- 2. Anglers Crest Subdivision 2024 Addition; KPB File 2024-019
Johnson Surveying / Ninilchik Native Association, Inc.
Location: Shavila Road, Matriona Drive & Kimeluk Street
Happy Valley Area**

**ITEM #2 - PRELIMINARY PLAT
ANGLERS CREST SUBDIVISION 2024 ADDITION**

KPB File No.	2024-019
Plat Committee Meeting:	March 25, 2024
Applicant / Owner:	Ninilchik Native Association Inc
Surveyor:	Jerry Johnson / Johnson Surveying
General Location:	Ninilchik along Sterling highway near Deep Creek Road

STAFF REPORT

Anglers Crest Subdivision 2024 Addition PRELIMINARY PLAT

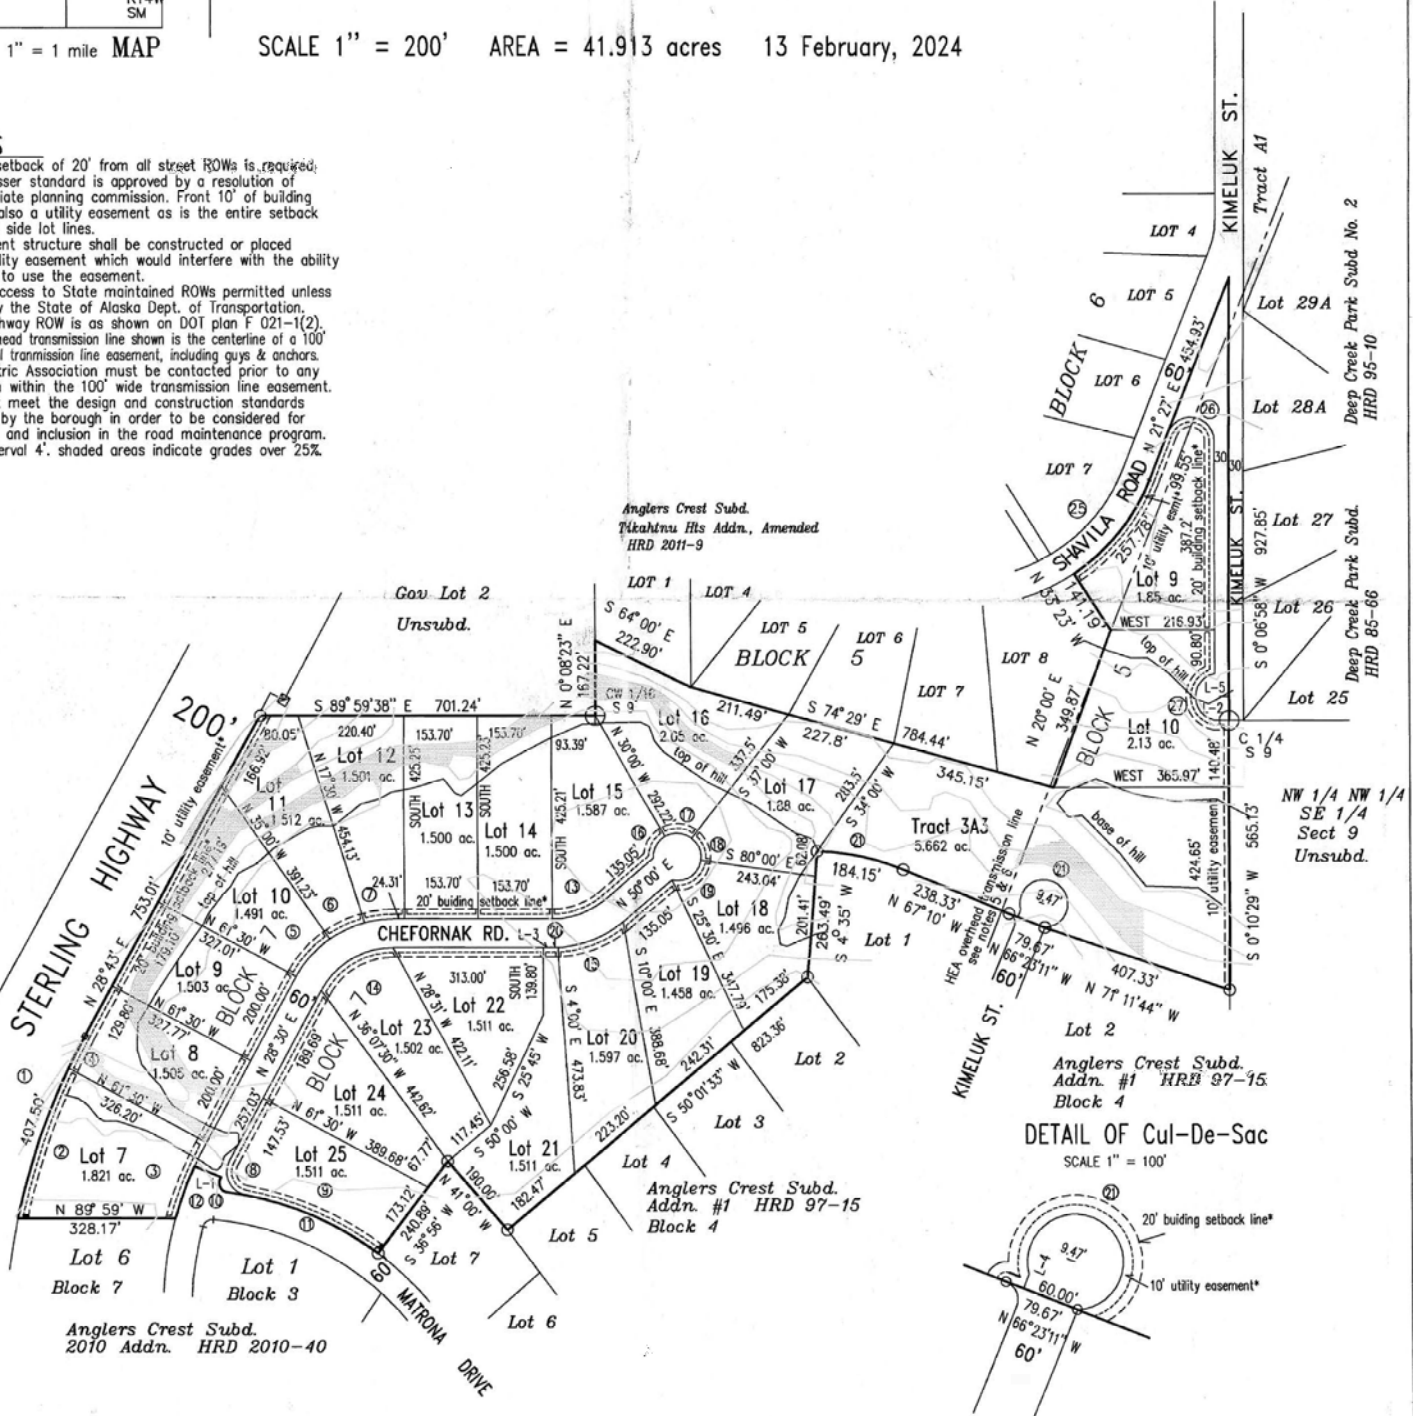
- Add KPB File No 2024-019 to title block.
 - Add name and ROW to road to southwest.
-

- D. A vicinity map, drawn to scale showing location of proposed subdivision, north arrow if different from plat orientation, township and range, section lines, roads, political boundaries, and prominent natural and manmade features, such as shorelines or streams;
Staff recommendation:
Add roads and names to map to get to site.

- G. The status of adjacent lands within 100 feet of the proposed subdivision boundary or the land status across from any dedicated rights-of-way that adjoin the propose subdivision boundary, including names of subdivisions, lot lines, block numbers, lot numbers, rights-of-way; or an indication that the adjacent land is not subdivided;
Staff recommendation:
Add block labels to the lots to the southeast of the plat

- L. Contours at suitable intervals when any roads are to be dedicated unless the planning director or commission finds evidence that road grades will not exceed 6 percent on arterial streets, and 1 0 percent on other streets;
Staff recommendation:
Contours are shown but there are no elevations given. The label on the east of 'base of hill' is deceptive as to where is the hill located. With elevations or added flowage arrows this could help.
-

Anglers Crest Subdivision 2024 Addition PRELIMINARY PLAT

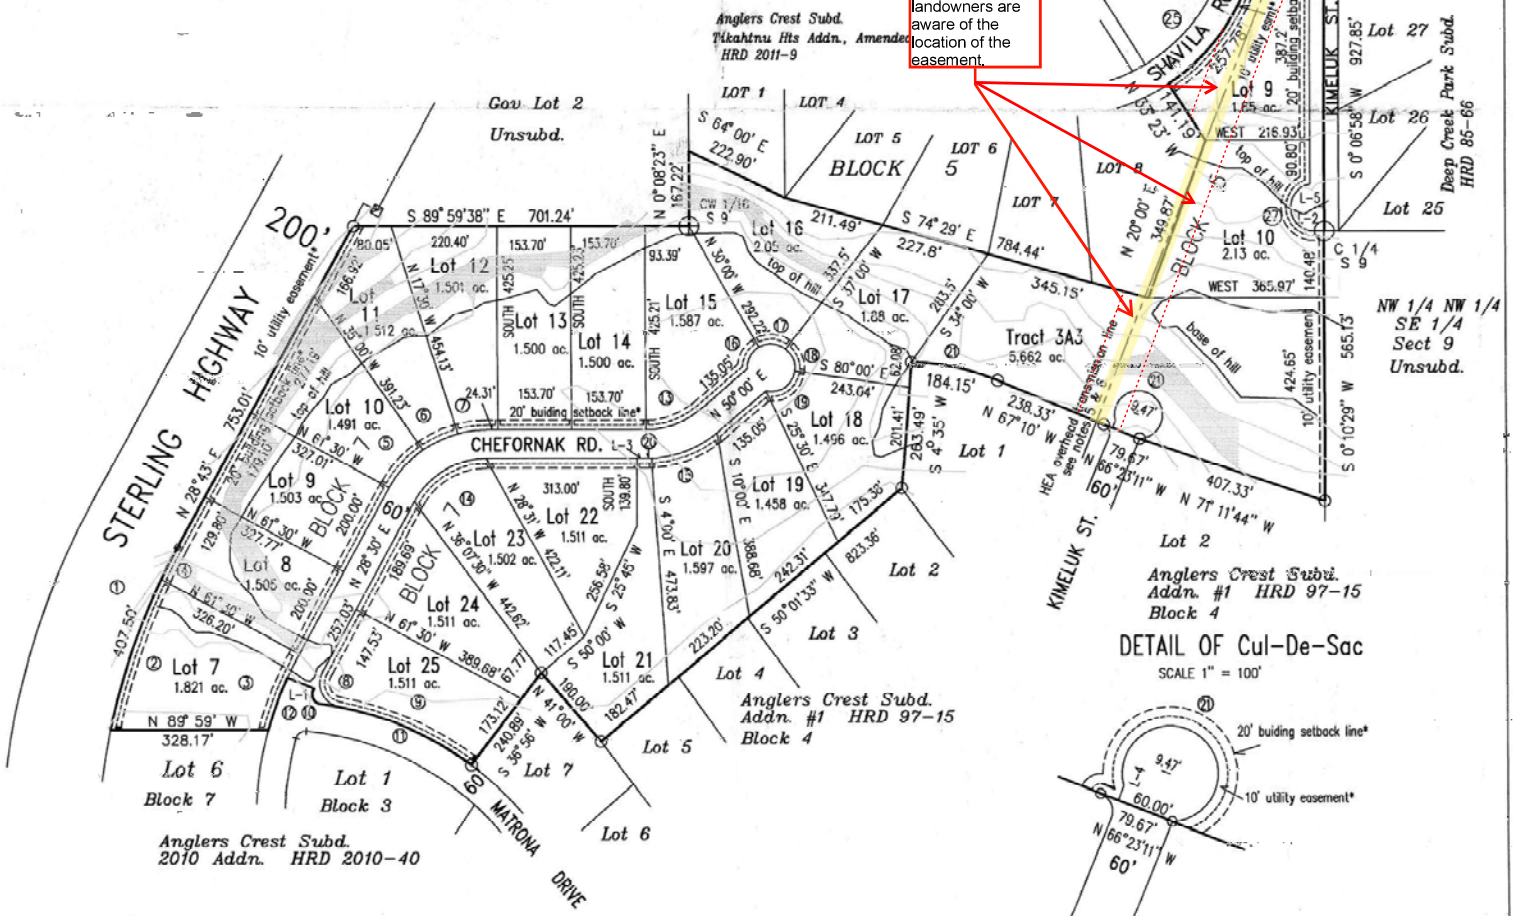
The standard plat note for a transmission line is as follows, 'The existing overhead electric transmission line is the centerline of a 100-foot-wide electrical transmission line, including guys and anchors, granted this plat. Construction of public roads shall be restricted to the outer 20 feet of one side or the other, but not both sides of the easement. Public roads or driveways crossing the easement shall be located as nearly perpendicular to the transmission line as is reasonably possible. No portion of a road or driveway shall be closer than 25 feet to a transmission line pole/structure. No excavation or fill within the easement is allowed without the express written permission of HEA.'

Plat notes 5 and 6 are acceptable to HEA and the surveyor can either use current plat notes 5 and 6 or the plat note provided by HEA.

Please show the limits of the 100 foot wide transmission line easement so landowners are aware of the location of the easement.
